**TOWN OF SCARBOROUGH
PINE POINT WORKING WATERFRONT
SCARBOROUGH, ME**

**ADDENDUM NO. 2
OCTOBER 1, 2010**

SK-1: PILE CAP SPLICE PLAN AND DETAIL

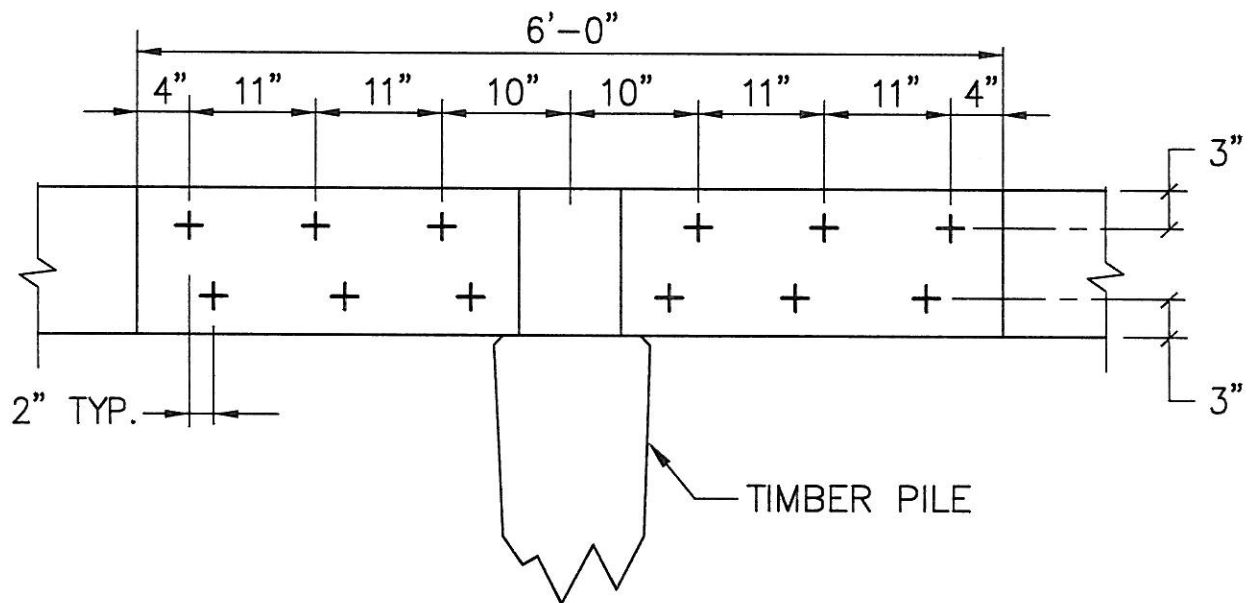
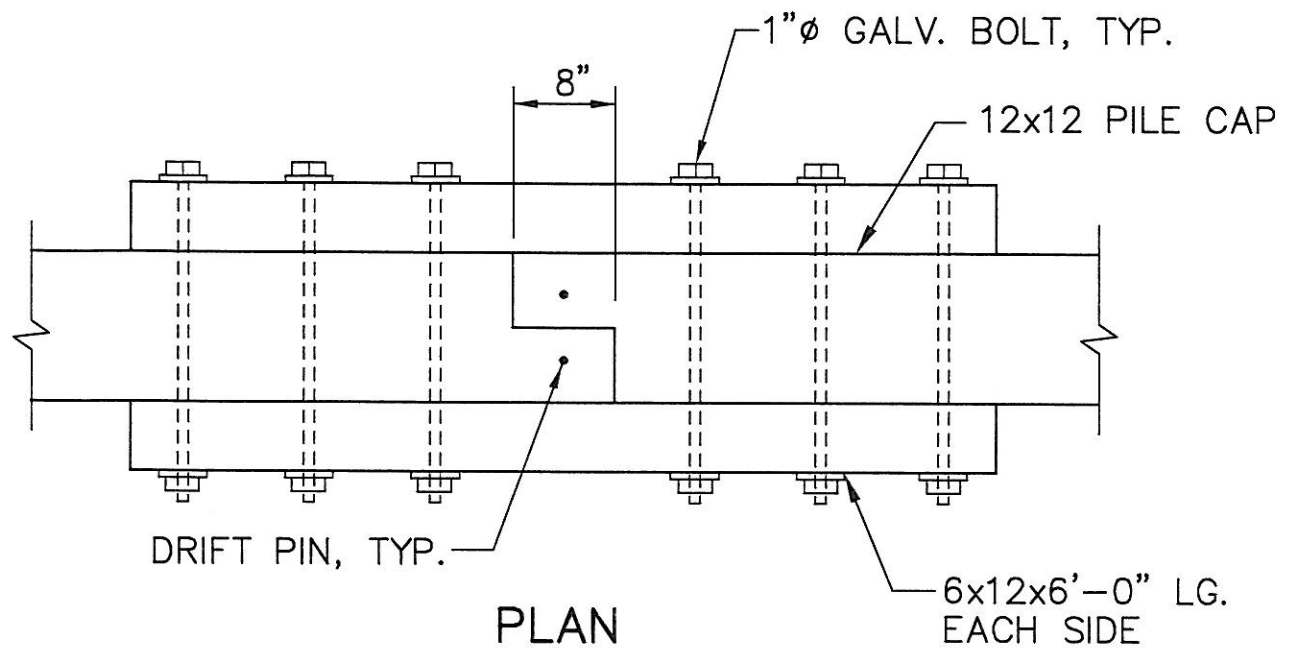
- 1.0 PLAN SHEET NO. 5 OF 11, PIER PILE, FRAMING AND DECK PLANS
 - 1.1 Framing Plan. Provide 12" X 12" Pile Cap splices in accordance with the attached sketch SK-1: PILE CAP SPLICE PLAN AND DETAIL by Fay, Spofford & Thorndike dated September 30, 2010.
- 2.0 PLAN SHEET NO. 6 OF 11, PIER DETAILS
 - 2.1 Ladder Details at Careening Area. Provide a continuous 10" X 10" Wale from the Careening Pile at Bent No. 9 to the Careening Pile at Bent No.10.
 - 2.2 Strap Detail. Provide one Steel Strap for each Careening Pile at Bent No. 8, 9, 10 and 11. Dap each pile and make the strap flush with the pile.
 - 2.3 Section at LightPole. Provide each Wood Pole as a Timber Pile.

ALL 12"x12" PILE CAPS SHALL BE SINGLE PIECE EXCEPT AT BENT LINE 17, 18 AND 19 WHERE ONE SPLICE IS ALLOWED AT PILE LINE F UNDER THE BASE BID. ONE ADDITIONAL SPLICE IS ALLOWED UNDER OPTION A OR OPTION B.
